Corrigendum-I

Refer IISER Mohali E-tender Ref. no. IISERM (895)17/18 Pur for **Supply of Electronics/Equipments(s) racks, coolant based server racks and compatible PDU,s for EHEP lab** at IISER Mohali, Sector-81, Knowledge City, PO-Manauli, SAS Nagar Mohali, Punjab. The following has been clarified based on the queries raised by supplier

Answer to the Queries and Corrections
to the Tender document IISERM (875)17/18Pur, 27/11/2017

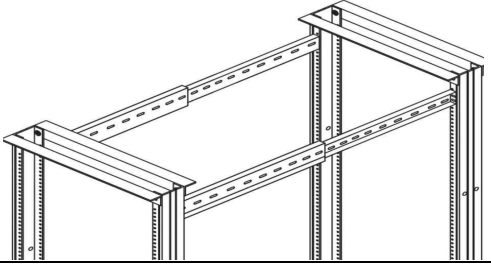
2. Clarification - Section A.1: 5th Bullet:

B. We will provide all 3-Phase power supplies. UPS is not in the scope of this tender, therefore bidders are not asked to provide any UPS.
